**Subject: Beaver Valley Power Station, Unit No. 1
BV-1 Docket No. 50-334, License No. DPR-66
Reply to Request for Additional Information Regarding
Order EA-03-009 Relaxation Request**

**Responses to NRC Questions
Regarding Beaver Valley Power Station (BVPS) Unit 1
Order EA-03-009 Relaxation Request**

Figure 6
Hoop Stress Vs Distance from Bottom of Weld
40.0° CRDM Penetration Nozzle - Downhill

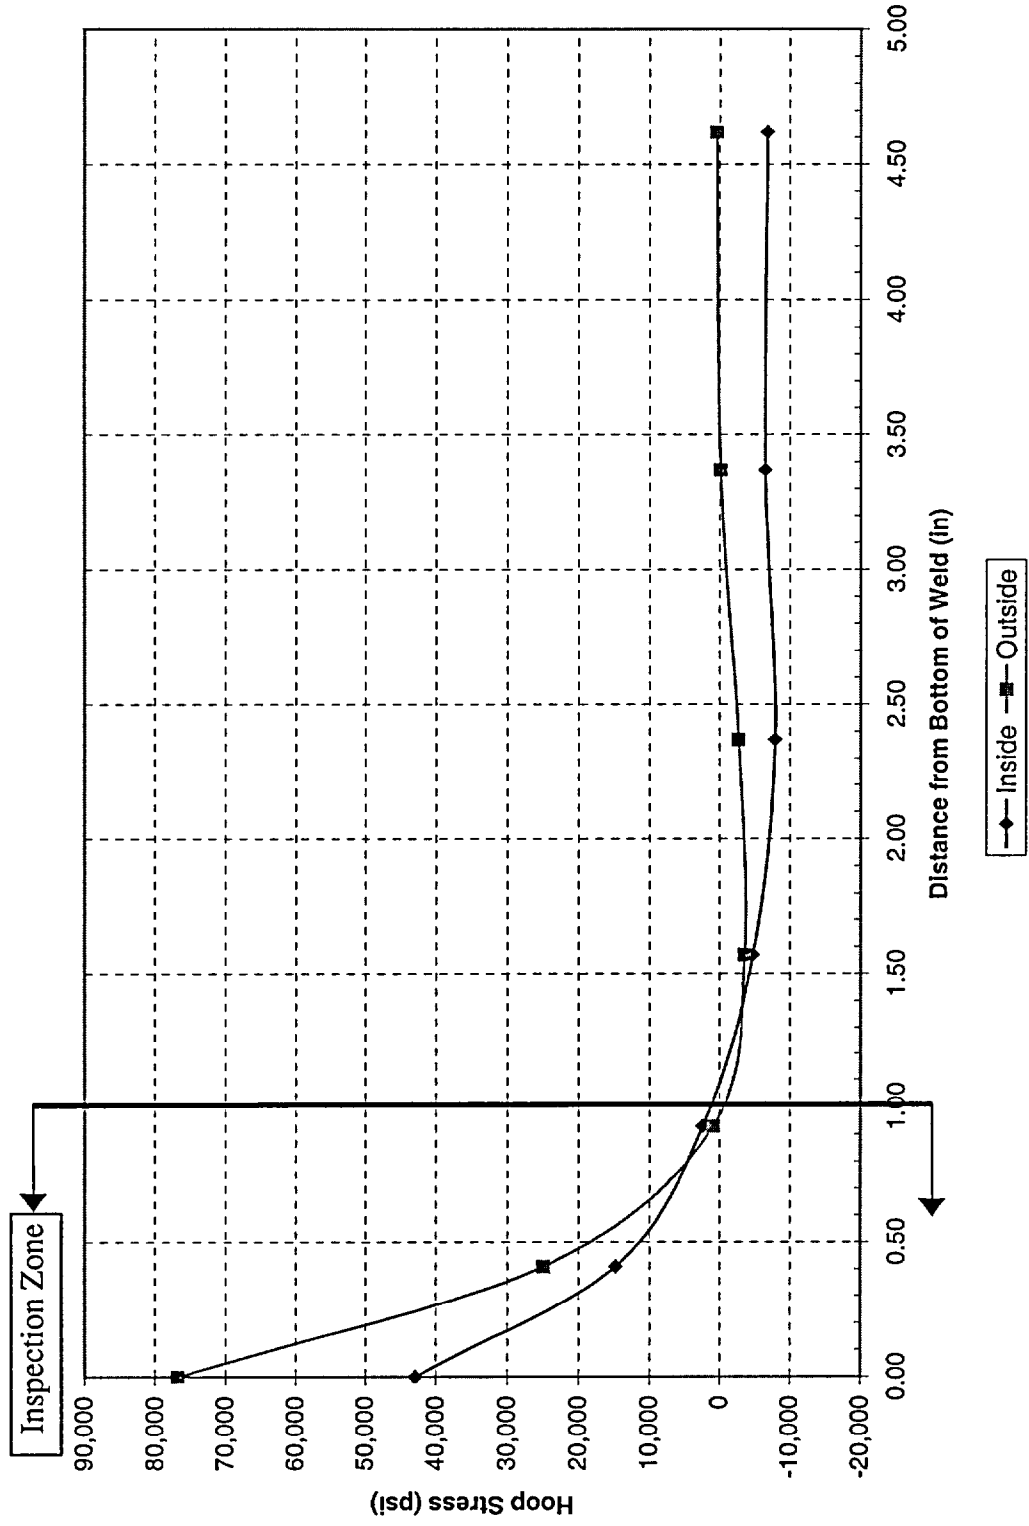
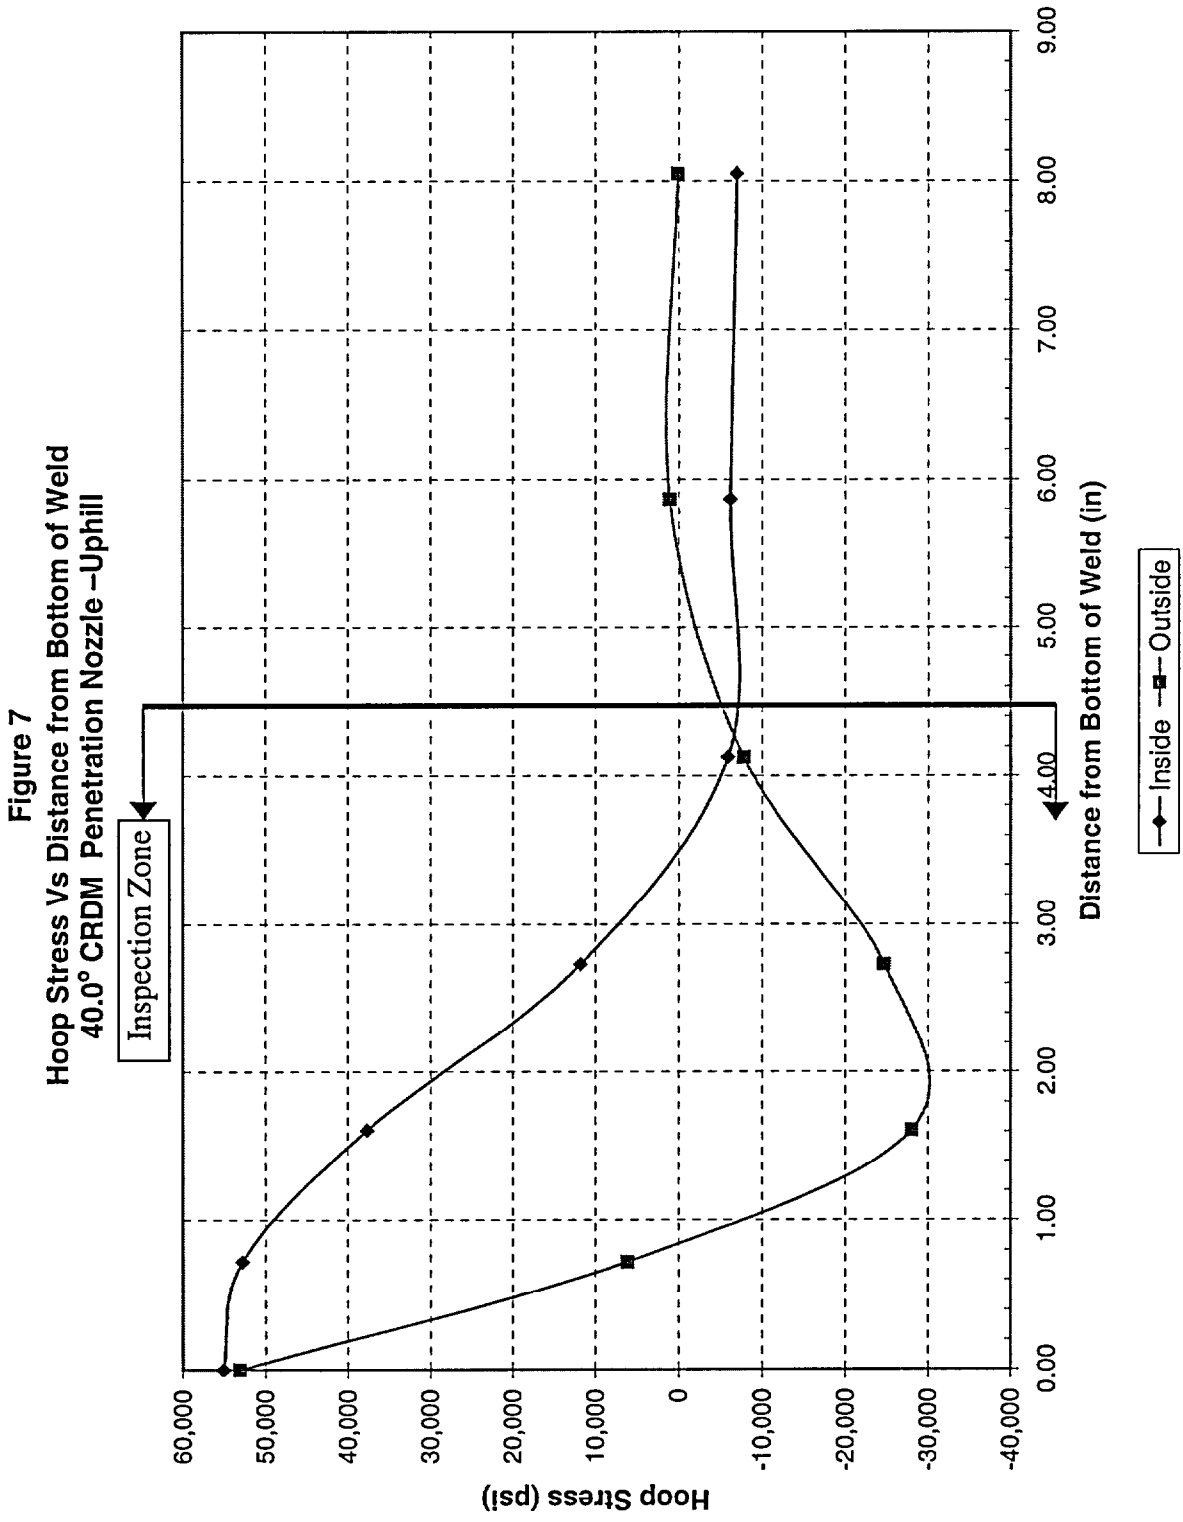
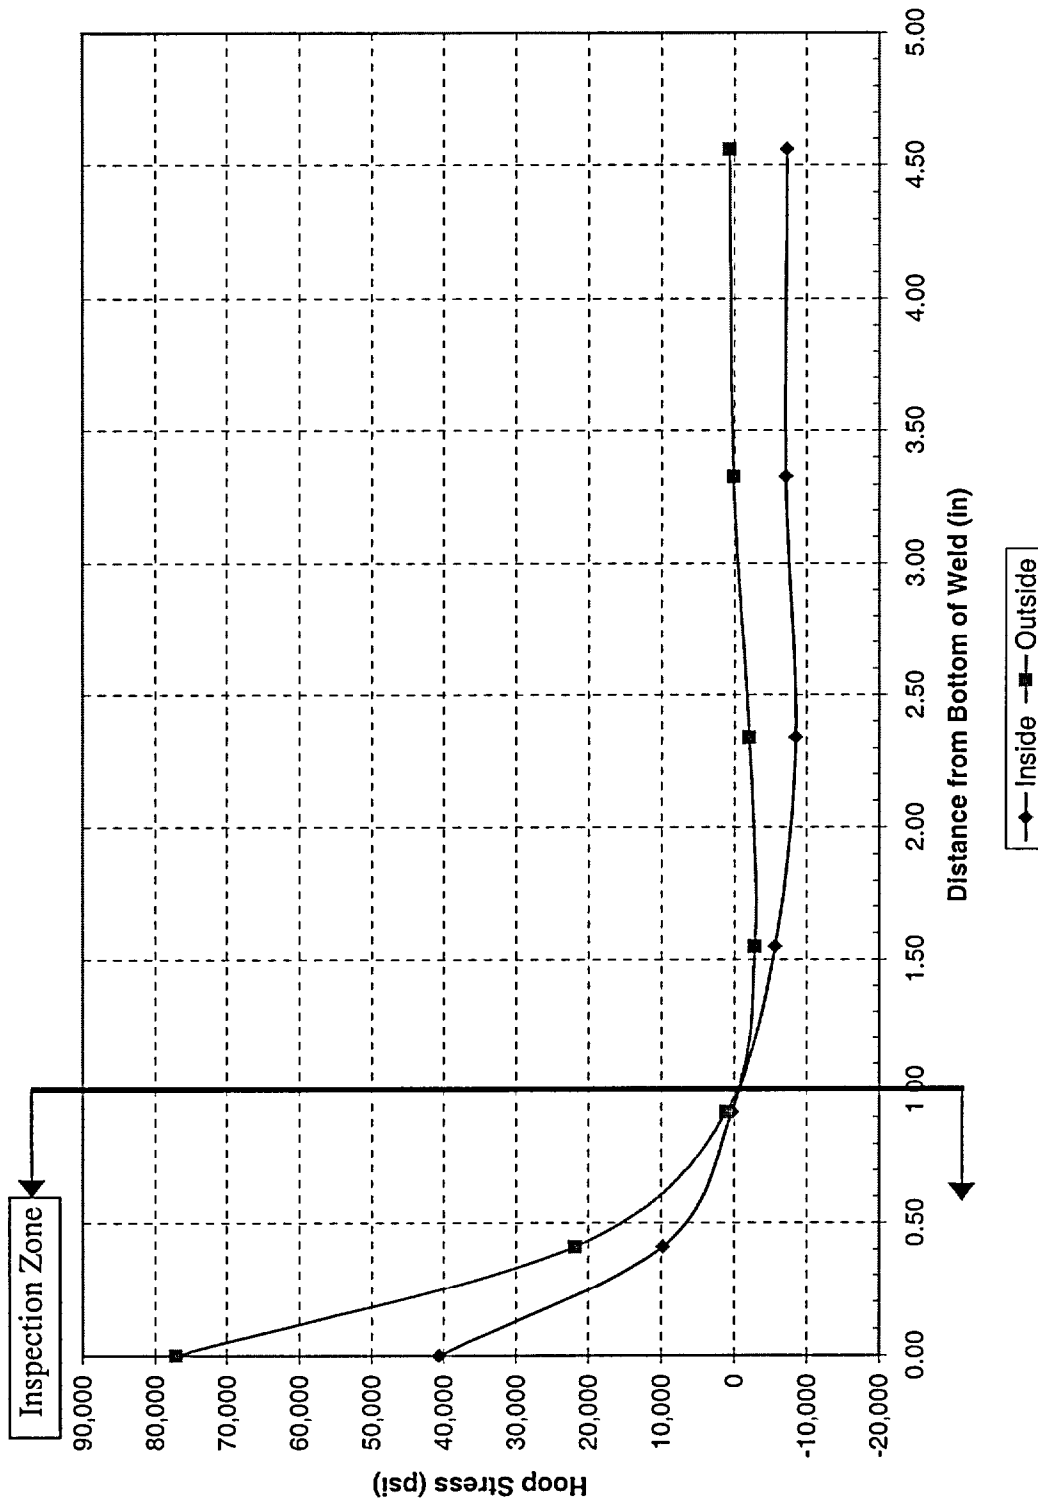
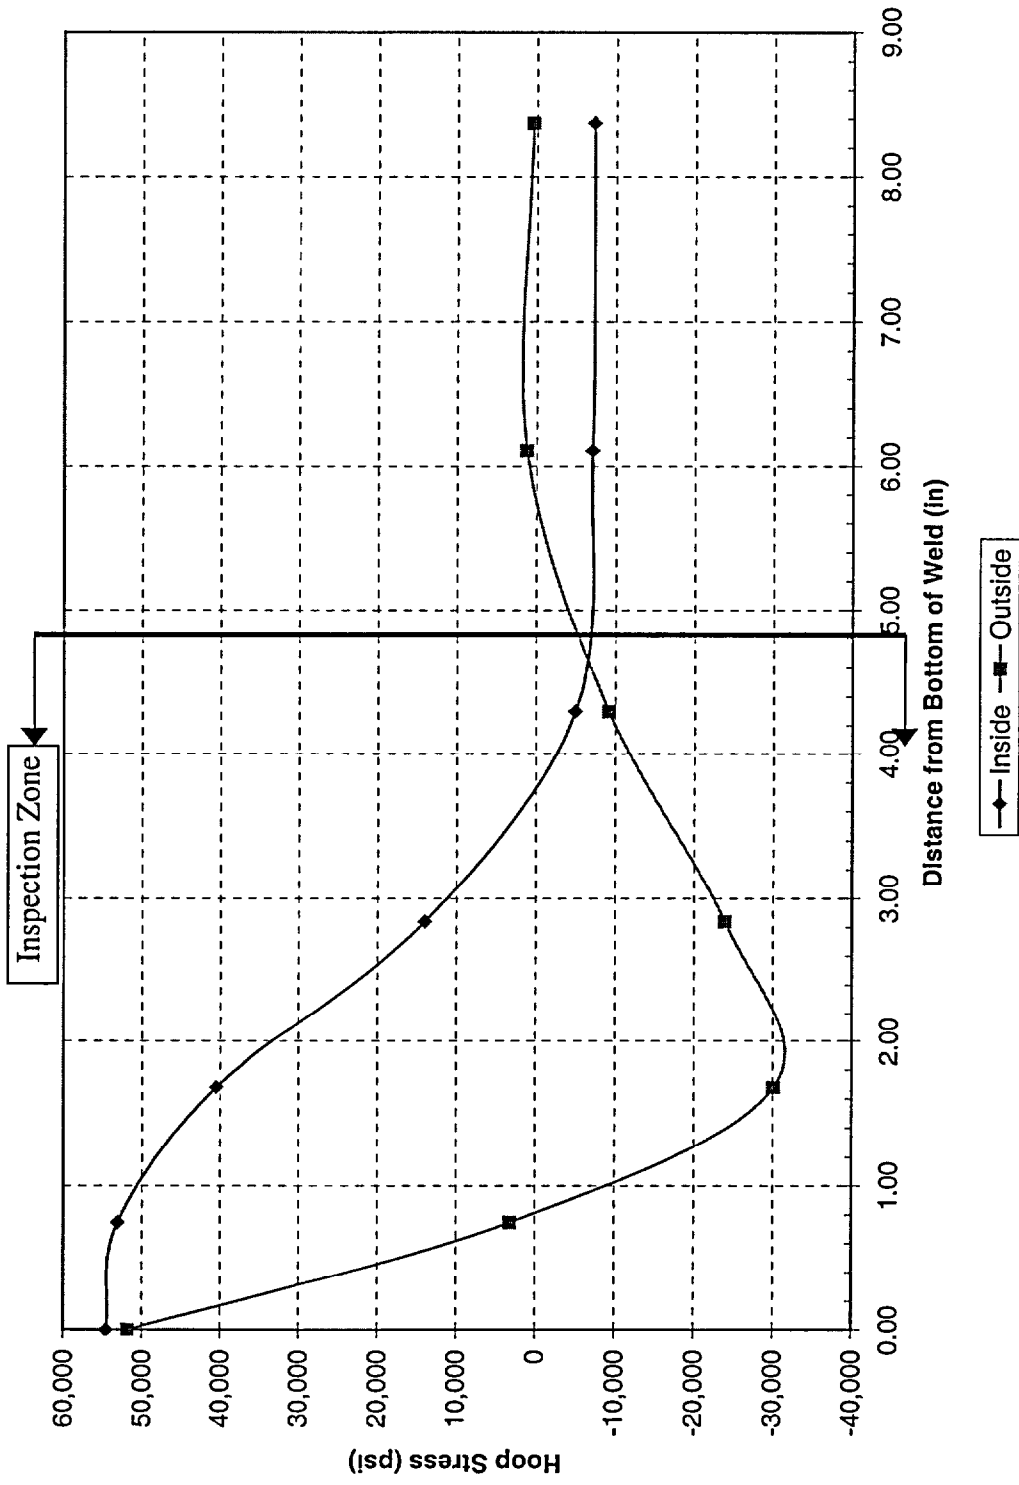
Question 2. *The request states that, "The magnitude of the stresses in these portions of the nozzles is low based on information from other plants of similar design and construction." Discuss how this information is applicable to your plant. Provide tabular listings of the maximum stress in the cross-section from the top of the J-groove weld region to the area covered by your relaxation request.*

The hoop stress distributions as a function of distance from the bottom of the weld for a range of penetration nozzles located at the center of the vessel head to the outermost nozzles are provided in Figures 1 to 9. The expected "inspection zone" is also identified in each figure. This information is provided in graphical versus tabular format. As shown in Figures 1 to 9, the magnitude of the stresses in the unexamined portion of the nozzles is low. See response to Question 3 for further information.

Figure 10
Through-Wall Axial Flaws Located in the 28.6 Degree Row of
Penetrations, Uphill Side - Crack Growth Predictions

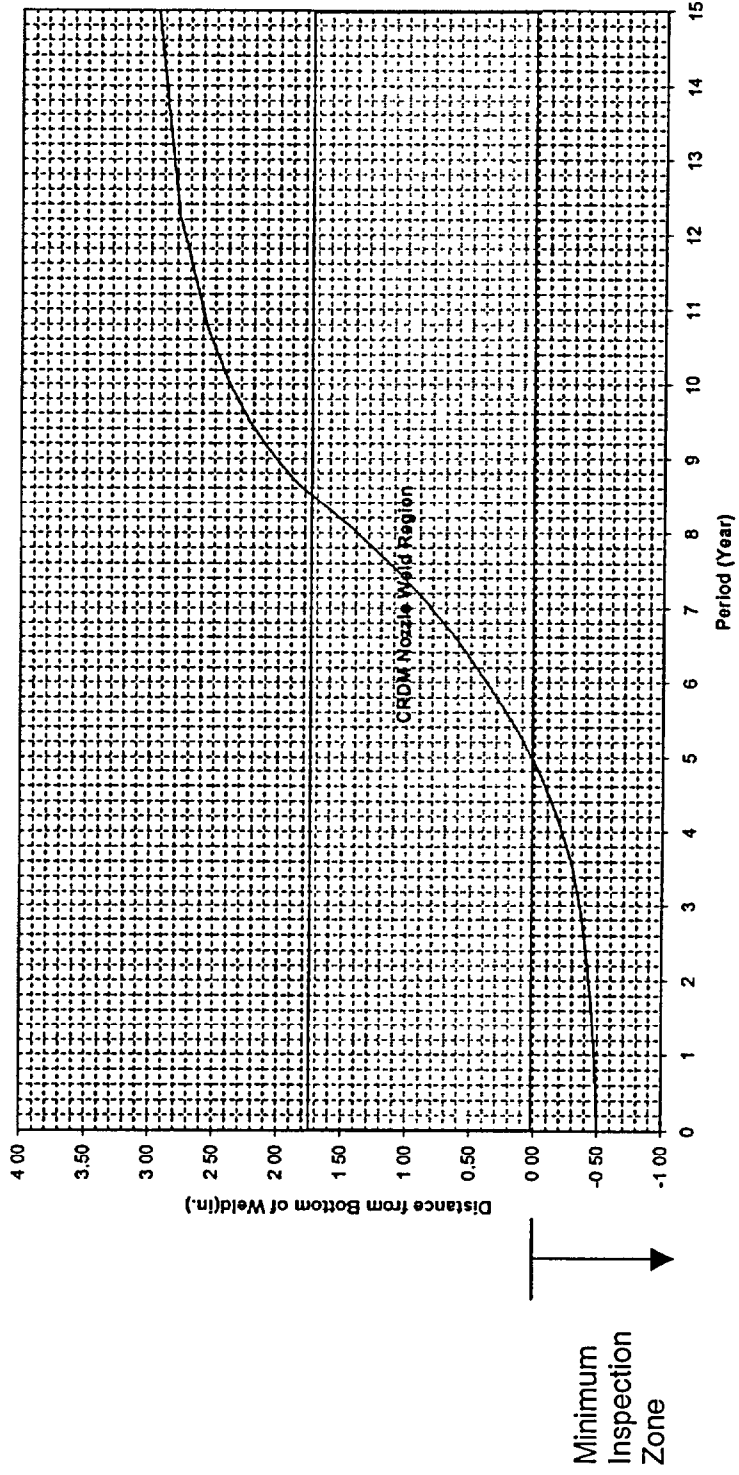
Question 3. The request also states that, "there are no concerns with the structural integrity of the vessel head penetration nozzles from the unexamined bottom portions of the nozzles addressed in this request." Provide the technical basis, such as an analysis or an evaluation to show that cracks initiated from the unexamined area will not propagate into the pressure boundary and exceed the Code allowable crack sizes within one operating cycle, based on a conservative crack growth rate from the industry operating experience.

The examination coverage from the bottom of the J-groove weld towards the bottom of the nozzle is expected to be a minimum of 1.0 inch. To determine the significance of such an axial flaw located more than 1.0 inch below the weld, a flaw tolerance approach is used. The flaw evaluation results obtained from a plant of similar design and construction as BVPS Unit 1 were used. See response to Question 2. The evaluation postulated an axial flaw in the unexamined area below the weld. The evaluations performed are based on a methodology consistent with the recently approved Section XI flaw evaluation approach, with a Primary Water Stress Corrosion Cracking (PWSCC) crack growth rate that is consistent with the MRP-55 Rev. 1 report. A through wall axial flaw was postulated in the nozzle material growing upwards towards the bottom of the weld. Since the stresses for the portion of the nozzle more than 1.0" below the weld are too low to propagate an axial flaw, the flaw evaluations start at 0.5" below the weld and the time to propagate the flaw in the nozzle to the bottom of the weld (start of the pressure boundary portion of the nozzle material or toe of the J-groove weld) was determined. Assuming a through wall flaw below the weld, with the flaw end located at 0.5" below the weld (which is in the area of complete examination coverage), an axial flaw would take approximately 5 years of operation to grow to the point of contact with the weld, and even longer for it to grow from the bottom of the weld upwards through the pressure boundary. This time period is significantly greater than the current inspection frequency of every refueling cycle (approximately 18 months for BVPS Unit 1) identified in NRC Order EA-03-009.

Figure 10 provides a graphical presentation of the above flaw evaluation discussion for the limiting penetration location. Based on the crack growth results shown in Figure 10, there are no concerns with the structural integrity of the reactor vessel head penetration nozzles that could be caused by axial cracking in the unexamined non-pressure boundary portion of the nozzle material for a period of approximately 5 years of operation.
